MEMORANDUM

TO: Cape Elizabeth Planning Board
FROM: Maureen O'Meara, Town Planner
DATE: September 15, 2020
SUBJECT: 14 Hill Way Site Plan, Subdivision Amendment

**Front Setback
Character Illustrations**

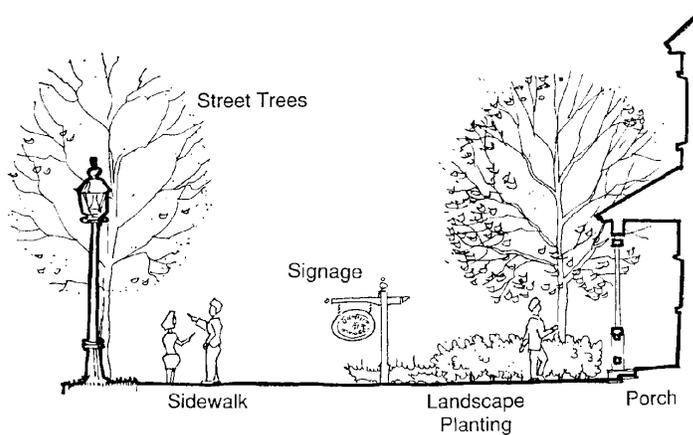
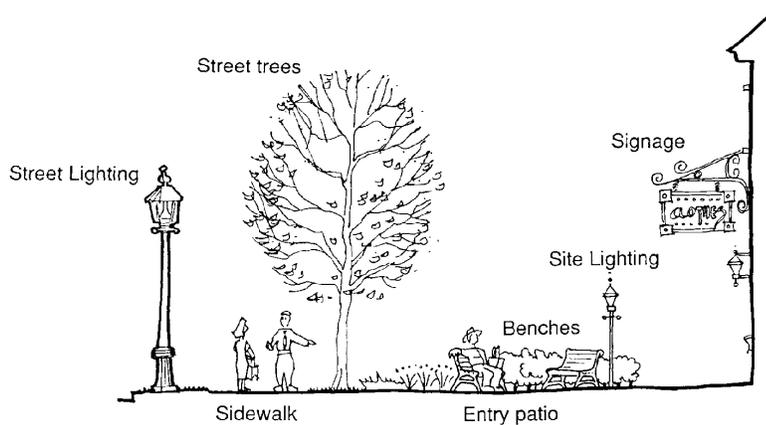
4. **Town Center Landscaping standards.** In addition to the site plan landscaping requirements, landscaping must also comply with Sec. 19-6-4(D)(g). The land in the front yard setback should be designed as a transitional space, pedestrian friendly in scale and access. The front yard should be visible to passing pedestrians, not walled off with landscaping as would be the case with the proposed forsythia/white cedar.
